**T.S.B. No.:**  
**AC No. 6 / 08**

**PRODUCT:**  
**Cimate Control**

**PART No.:**  
**817824**

**SUBJECT:**  
Change to technical  
reference code

Technical drawing of CA1458

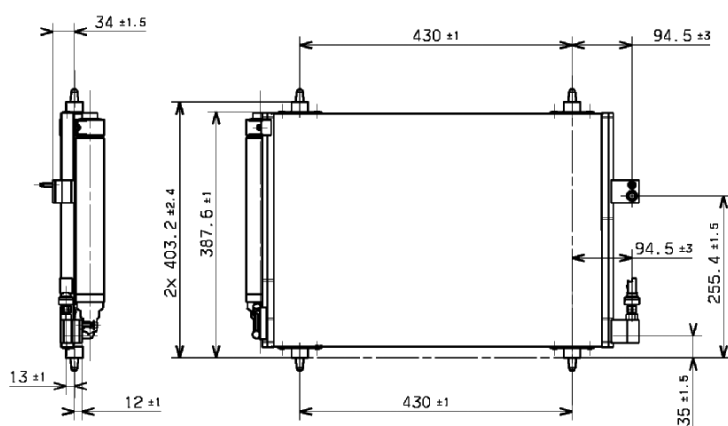
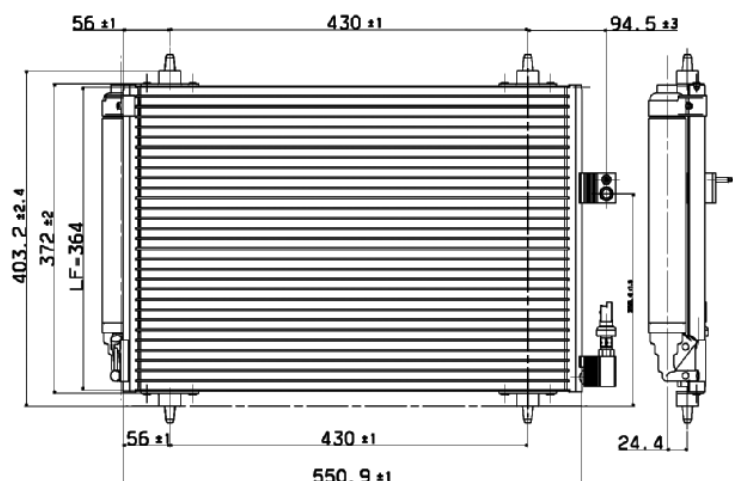
The condenser fitted to the new Citroen C5 2008>, with technical reference code CA1542, measures 3mm less in width to 817824 (CA1458).

Valeo Service can confirm that both condensers are interchangeable.

817824 reference is maintained but technical code CA1458 is replaced by CA1542.
